S-Comm Technologies Pty. Ltd.

Technical response to the ACMA consultation on the Queensland DRCP

for
EON Broadcasters

Figure 3-11: : Coverage from Mt Coot-tha using the Alt-2 pattern plus the Mt Mee repeater using the shadow option – northern area

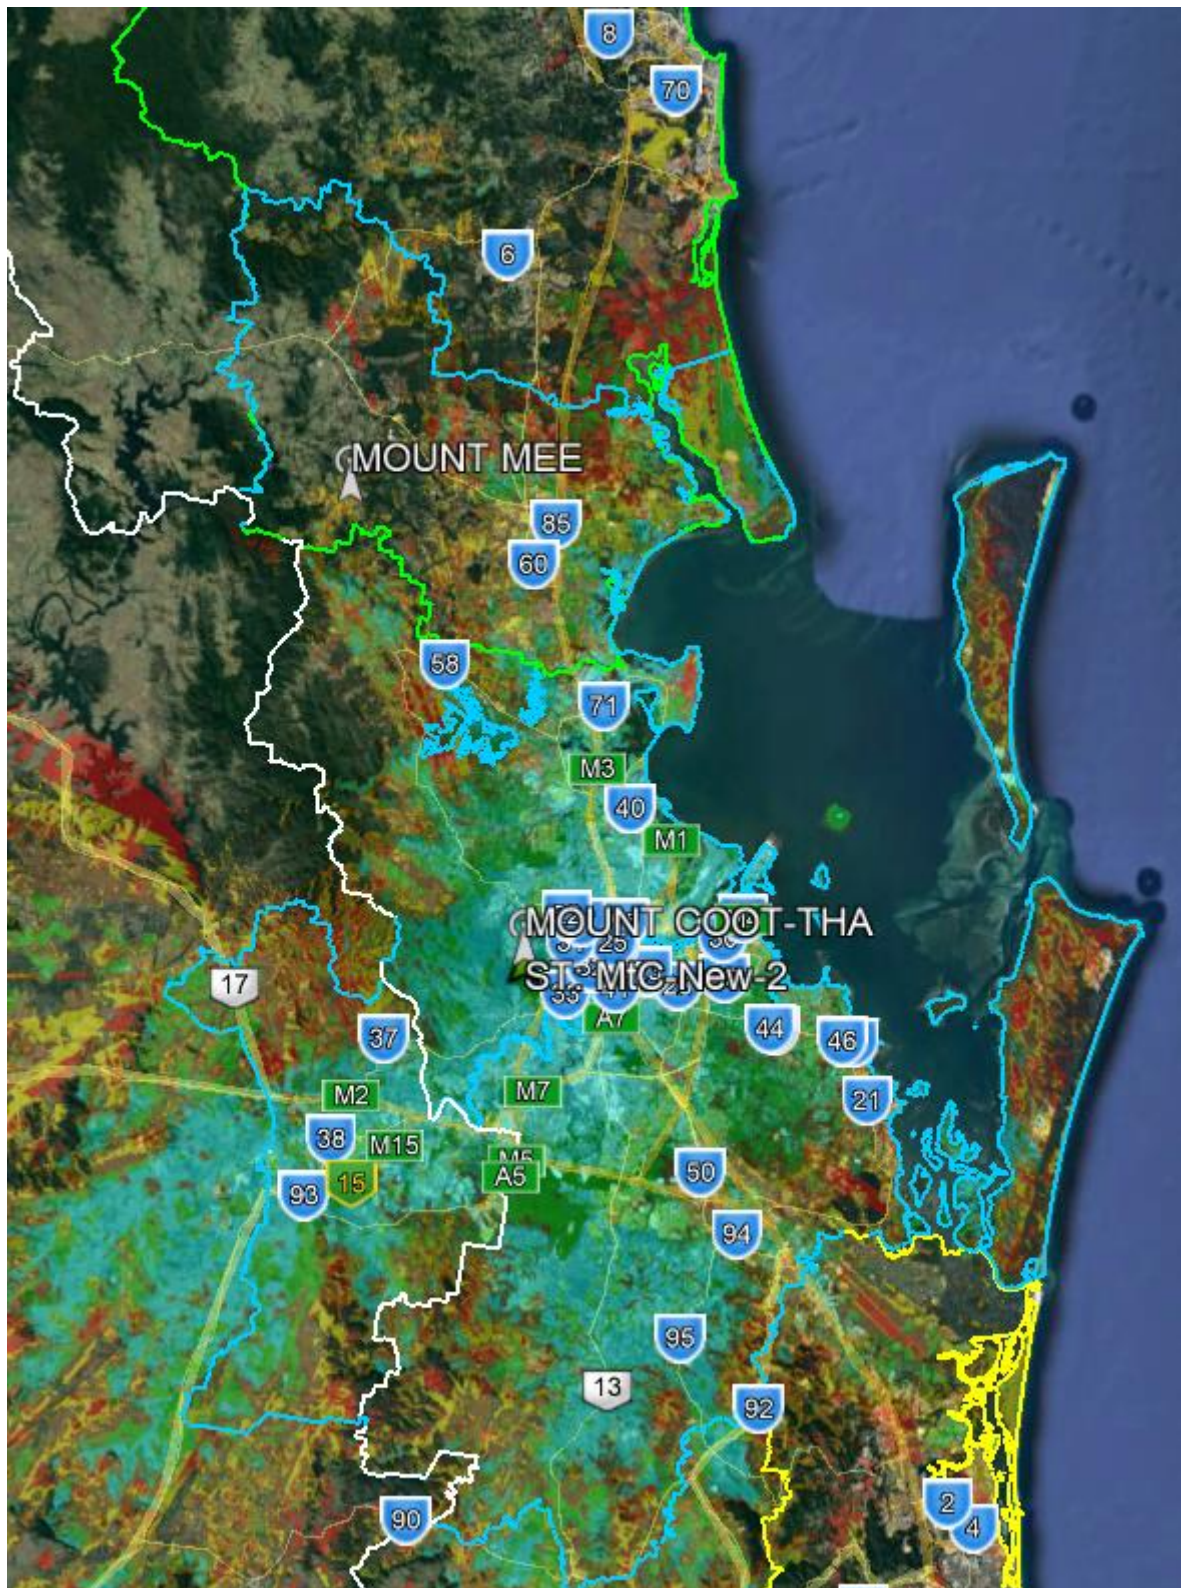
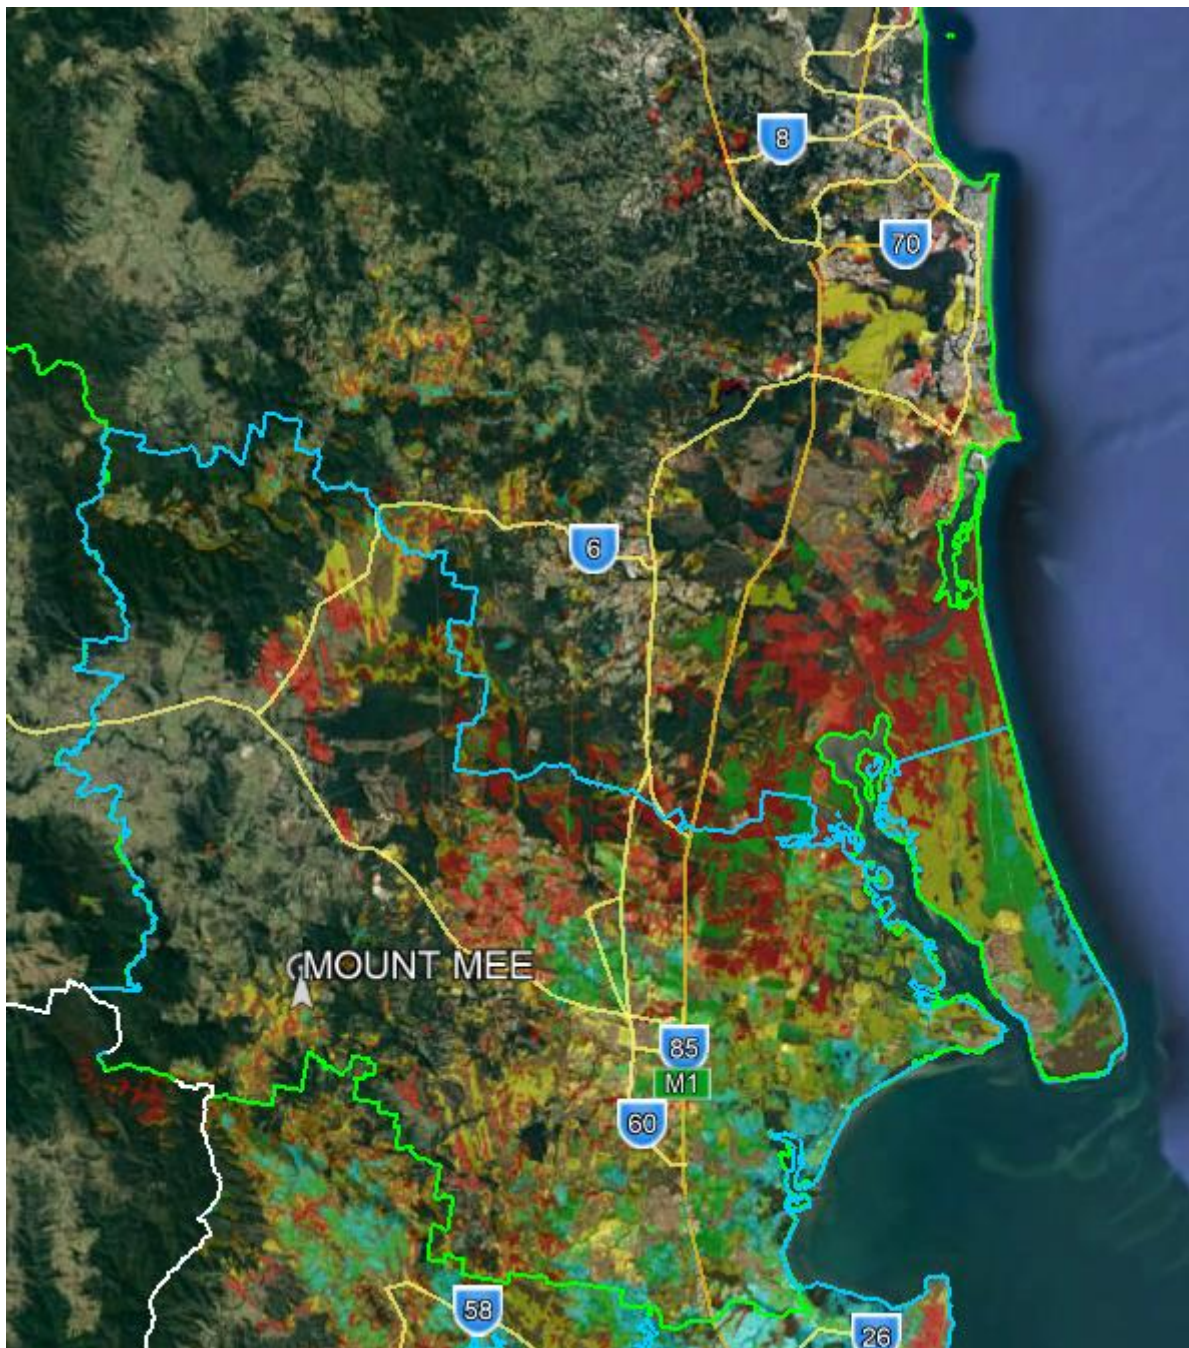
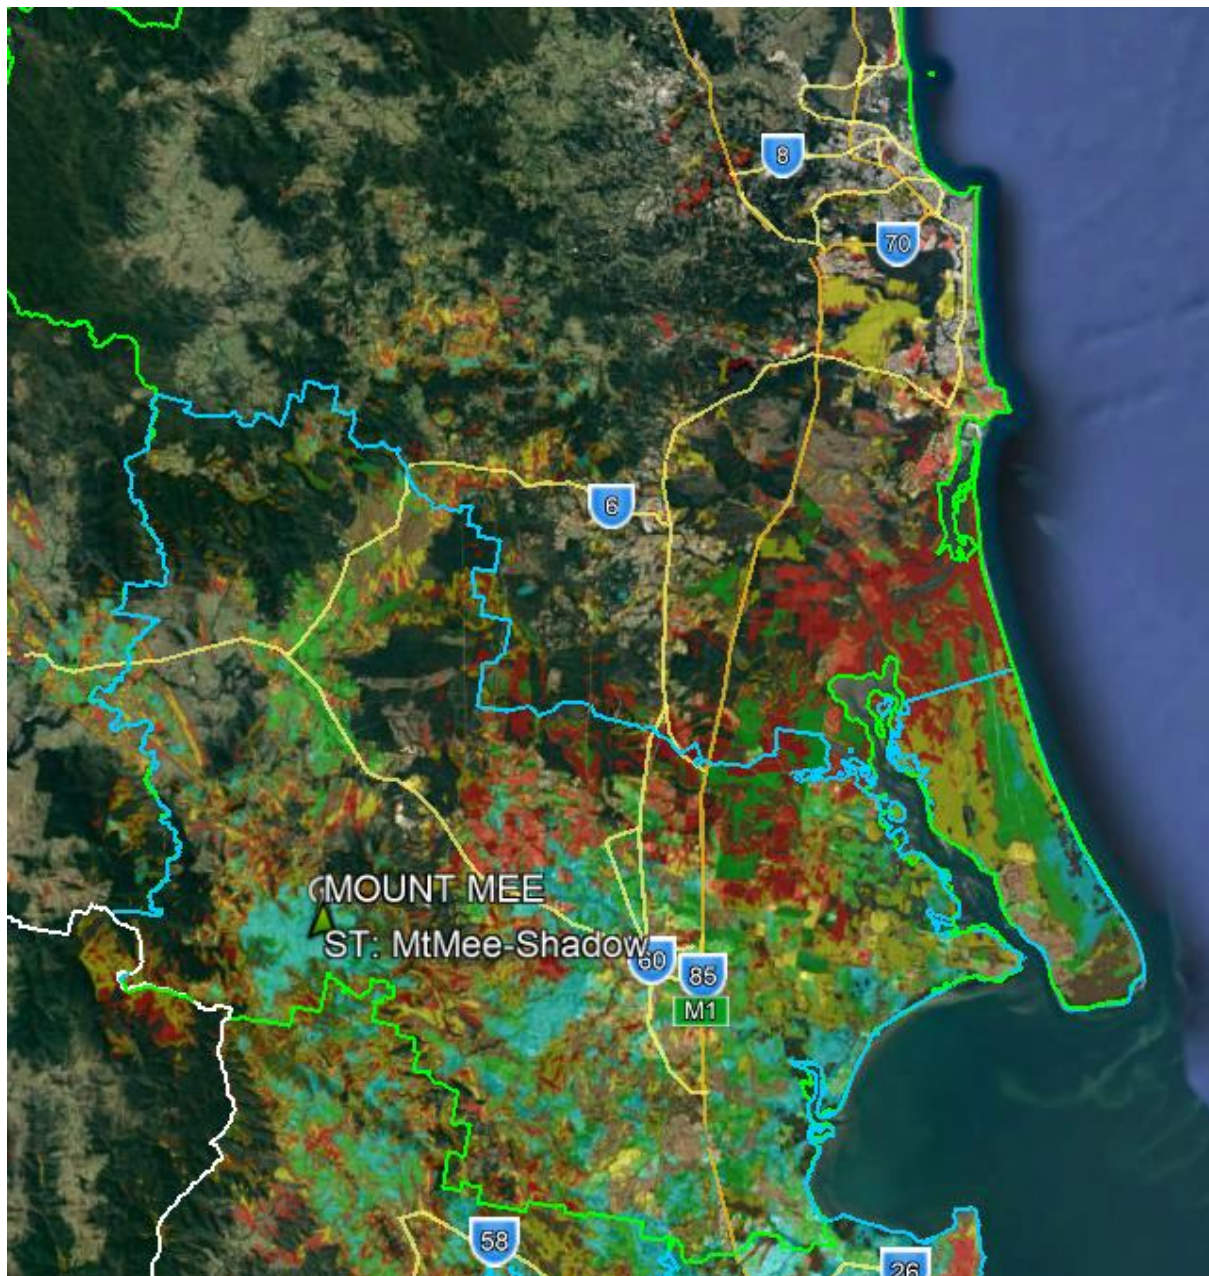
The resulting coverage provided by Mt Coot-tha is shown in Figure 3-9 and Figure 3-10 with the combination of the Mt Coot-tha transmission at 50 kW ERP and the Mt Mee transmission using the shadowed antenna option at 500 W ERP shown in Figure 3-11.

The coverage from the Mt Coot-tha transmission only provides good coverage of the main population centres in the Caboolture shire area as well as most of the main roads but fails to deliver any useful coverage in the very north west of the Brisbane RA1 licence area which is one of the

targets of the Mt Mee repeater. Figure 3-11 shows that the north west area receives good coverage from Mt Mee with the exception of a 4.6 km section of the D'Aguiar highway which has shadowing from a local mountain.
